## FINAL REVIEW CITY OF ALLENTOWN, PENNSYLVANIA HARB July 12, 2019

Case # HDC-2019-00017 - Proposal to do façade improvement, restoration and rehabilitation

**Property located at:** 219 N 10<sup>th</sup> Street

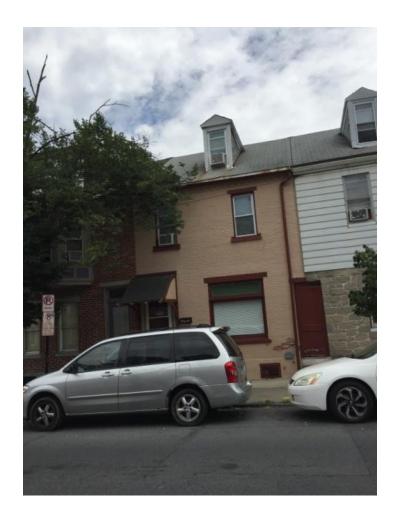
**Evaluation, effect on historic district, recommendations**: The proposed work is historically appropriate with the following clarifications or recommendations:

- Follow Preservation Brief #1 and 2 for paint removal and repointing using a high lime content mortar
- GAF Slateline shingles in Antique Slate color would be appropriate if natural slate financially not feasible
- It is recommended to remove all windowsill and trim capping. Replacing vinyl replacement windows with 1/1 Aluminum clad wood windows is highly recommended
- Replacement of entry door and storm door is historically appropriate. A ¾-light wood door with lower panel matching the door at 221 N. 10<sup>th</sup> is suggested.
- Replacement of deteriorated grocer alley door with similar or more historic paneled door is recommended.
- All other items are historically appropriate with staff approval of light fixture recommended

**Discussion:** Mr. Lewnes explained that the existing door transom was covered, and a light fixture installed under the Liberty Bell roof. He said he proposed to keep the existing conditions. In addition to the proposed work Mr. Lewnes asked if louvered wood shutters could be added to the list. He found existing pintle hardware proving that shutters were on the building historically. He also added that the existing first floor window transom had inappropriate plastic material in it, and he would like to install new regular glass.

- a. Existing paint will be removed from brick and brick repaired and repointed as needed. Preservation Briefs #1 and #2 ware to be followed.
  - The existing roofing will be repaired as needed or replaced with natural slate or GAF Slateline fiberglass shingles (or equivalent)

- c. Vinyl windows will be replaced, if possible, with aluminum clad wood windows to fit the historic openings. All aluminum capping will be removed
  - d. The inappropriate material in the first floor window transom may be replaced with new clear glass.

- e. Louvered wood shutters will be installed on the second floor windows utilizing existing hardware.
  - f. The existing front door will be replaced with an historically appropriate ¾ or ½ -light door with lower panels. The existing storm door will be replaced with a bronze aluminum full light storm door

- g. The grocer's alley door will be replaced with a historically appropriate paneled door
  - h. All woodwork and dormer will be repaired in-kind and painted.

- Existing downspout will be painted or replaced with new painted round downspout, if needed

- i. All iron work will be painted flat black.
- j. Street address will be added to the door frame or transom
- k. The existing mailbox will be removed, and a mail slot installed in the door.
